JLG 16076 Phillips Aquatics Community Center

RE: Addendum 4

Issued: October 7, 2016

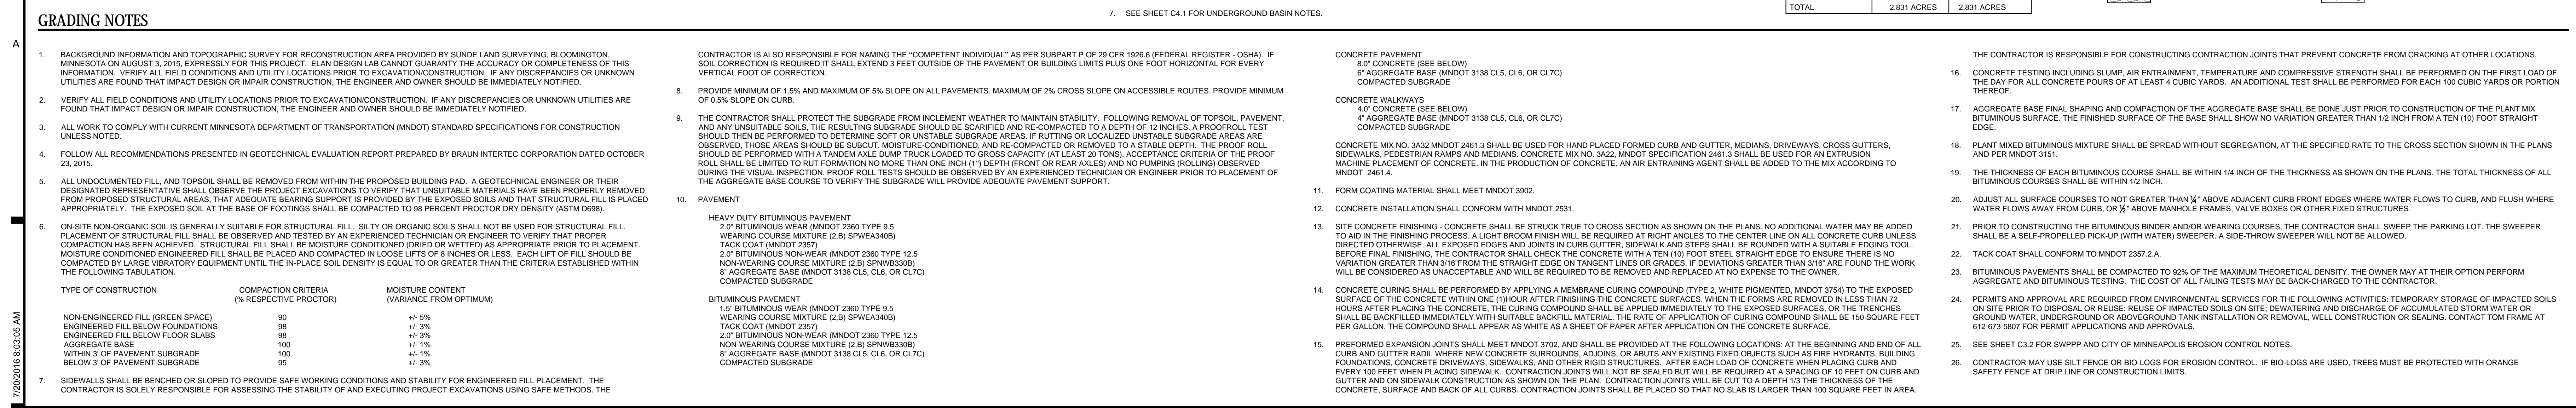
- A612 - INTERIOR ELEVATIONS
 - Detail 1A & 1B/A612 - Typical hook mounting in both existing and new pool areas, location as shown on drawings; Change solid surface to Aluminum C channel, 16 ga. Mount hooks to C channel; mount channel to precast wall panels with 1/2" wedge anchors @ 48" o.c. max, coordinate anchors location with precast panels manufacturer.
- C101 - DEMOLITION PLAN
 - Update pavement removal area on E 24th Street.
